RE: **Utility Trailer Sales**
8201 Daytona Rd NW
Grading Plan Stamp Date: 5/25/18
Drainage Report Stamp Date: 5/14/18
Hydrology File: K09D026B

RE: Utility Trailer Sales
8201 Daytona Rd NW
Grading Plan Stamp Date: 5/14/18
Drainage Report Stamp Date: 5/14/18
Hydrology File: K09D026B

**RE: Utility Trailer Sales
8201 Daytona Rd NW
Grading Plan Stamp Date: 4/30/18
Drainage Report Stamp Date: 4/30/18
Hydrology File: K09D026B**

ENGINEER'S SEAL  VINCENT P. CARRICA P.E. #16212	UTILITY TRAILER SALES ALBUQUERQUE NM CONCEPTUAL GRADING AND DRAINAGE PLAN	DRAWN BY LA
		DATE 05/23/2018
 TIERRA WEST, LLC 5571 MIDWAY PARK PLACE NE ALBUQUERQUE, NM 87109 (505) 858-3100 www.tierrawestllc.com	2017041-GRADING 2	SHEET # C2
		JOB # 2017041

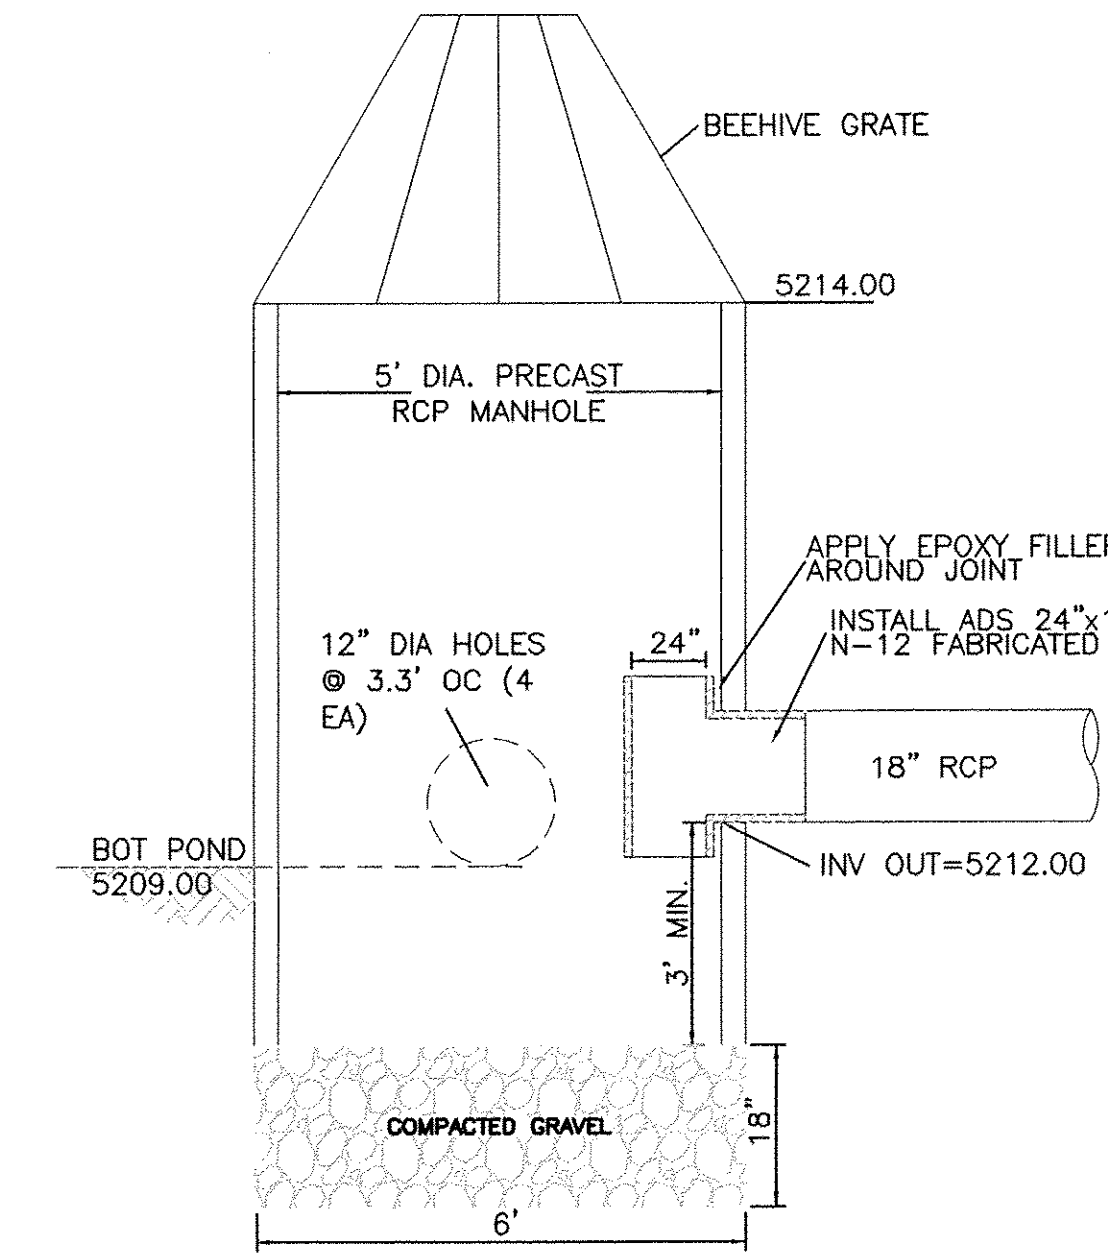
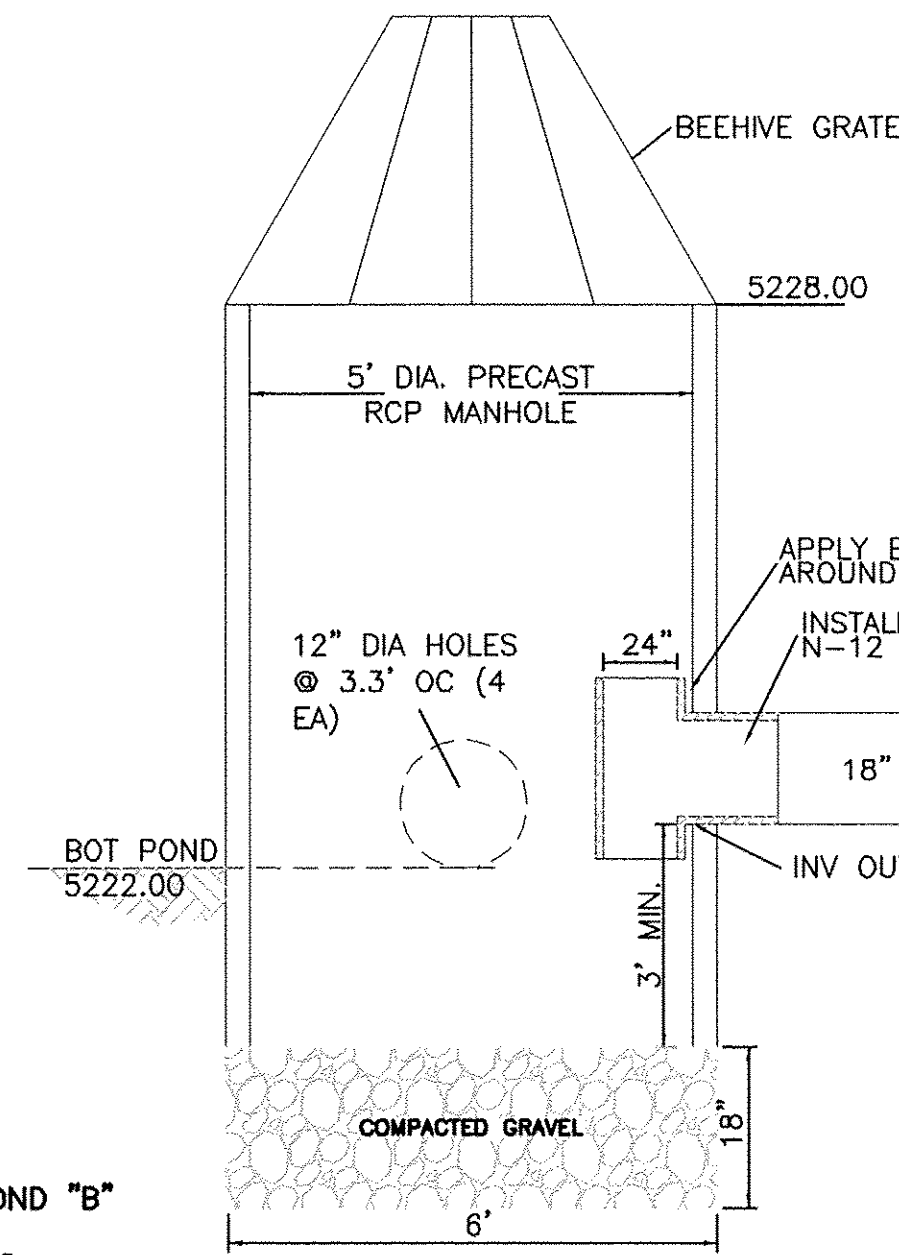
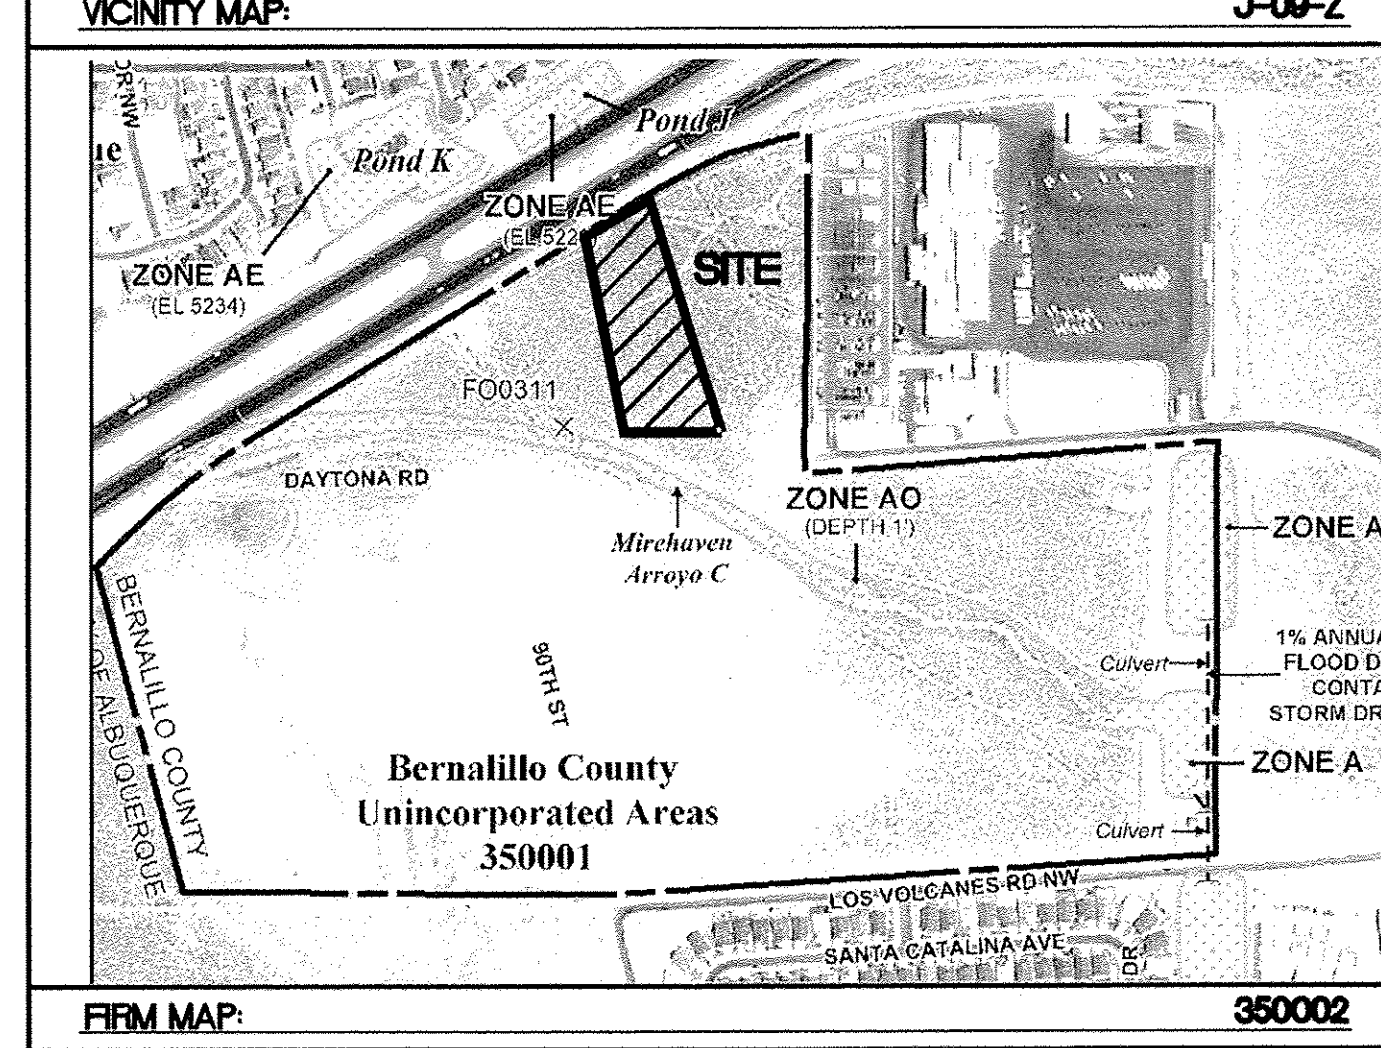
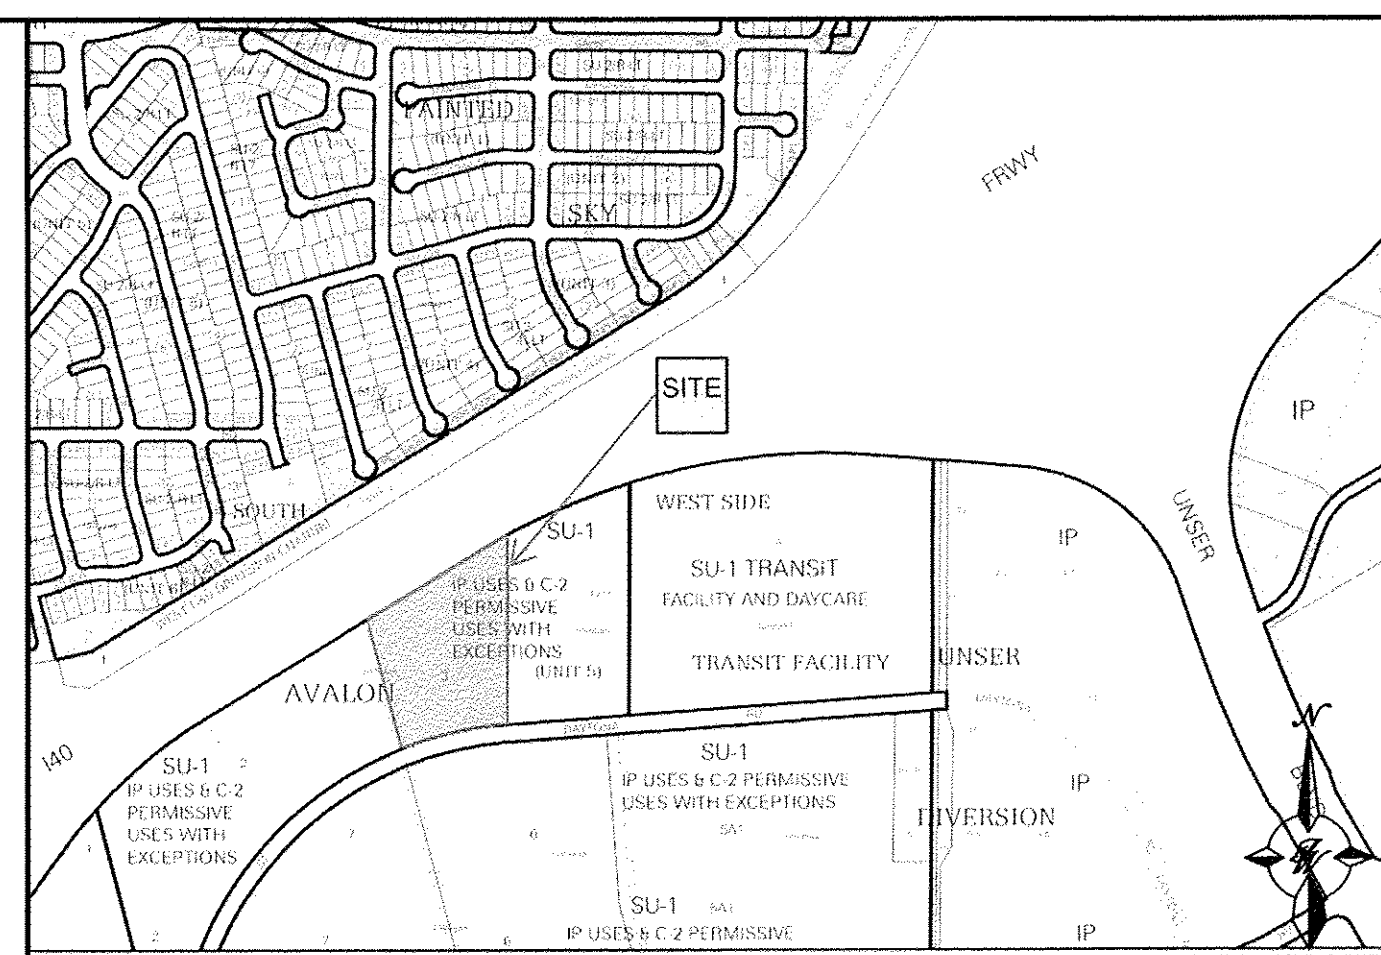
1. The grading in the SE corner of the site does not support the proposed drainage pattern. For instance the contours and spot elevations do not indicate a swale along the property line, connecting the two first flush ponds. The SE corner is lower than the InvertOut of the adjoining pond riser (5012.00' vs ~5010.20'-5011.00'). The grading in this area will need to be reworked to ensure a clear flow path from Pond A to Pond B to the 18" RCP into Daytona. Pond B bottom and InvertOut will likely need to be lowered.

2. There are a few proposed spot elevations and contours across the property line onto Bruckner's property. Please correct to show no grading across the property line here. If this work is required, written and signed permission will need to be obtained from the property owner.

4. The grading in the SE corner of the site does not support the proposed drainage pattern. For instance the contours and spot elevations do not indicate a swale along the property line, connecting the two first flush ponds. The SE corner is lower than the InvertOut of the adjoining pond riser (5012.00' vs ~5010.20'-5011.00'). The grading in this area will need to be reworked to ensure a clear flow path from Pond A to Pond B to the 18" RCP into Daytona. Pond B bottom and InvertOut will likely need to be lowered.
5. There are a few proposed spot elevations and contours across the property line onto Bruckner's property. Please correct to show no grading across the property line here. If this work is required, written and signed permission will need to be obtained from the property owner.
